Revision History

Orderable: N/A	Designed for: Public Release	Mod. Date: 11/24/2017
TID #: PMP30387	Project Title: tiny FlyBuckBoost IGBT driver	
Number: PMP30387	Rev: B	Sheet Title:
SVN Rev: Version control disabled	Assembly Variant: [No Variations]	Sheet: 1 of 2
Drawn By:	File: PMP30387RevB.SchDoc	Size: A4
Engineer: B. Geck	Contact: http://www.ti.com/support

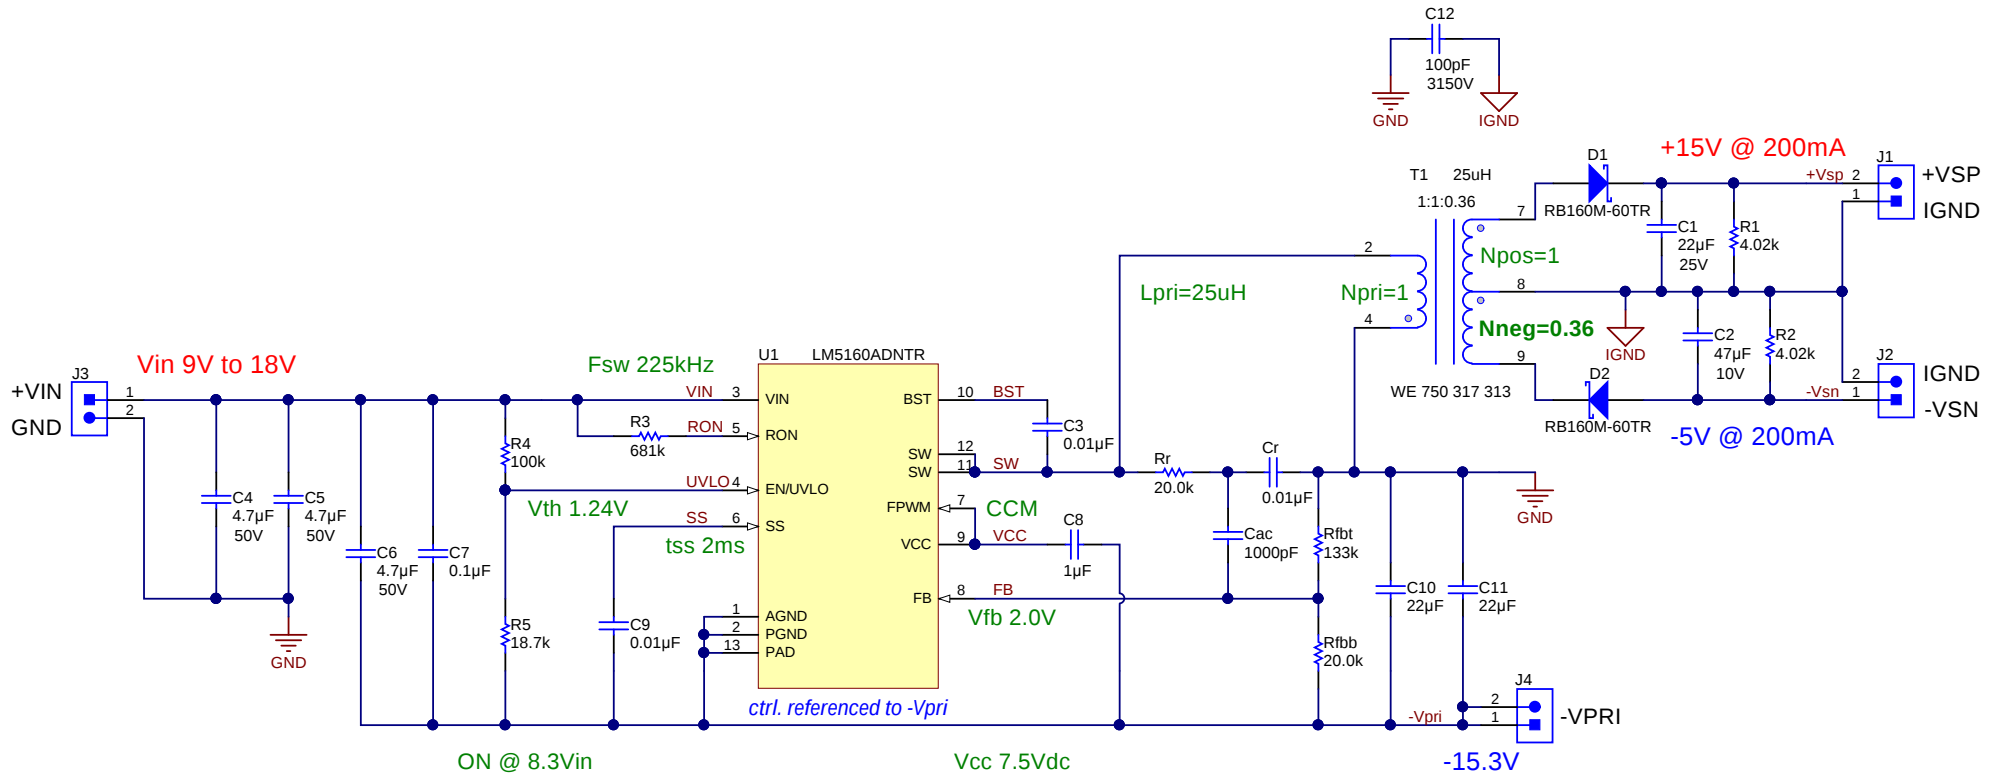
- 1) built on PCB 10654 RevB
- 2) windings ratio Nneg changed from 0.6 to 0.36
- 3) T1 has same pinout and geometry as WE 750 315 445

- 1) THT drills for T1 are big - solder carefully
- 2) bottom silk screen +VSP/-VSN/VIN/GND wrong
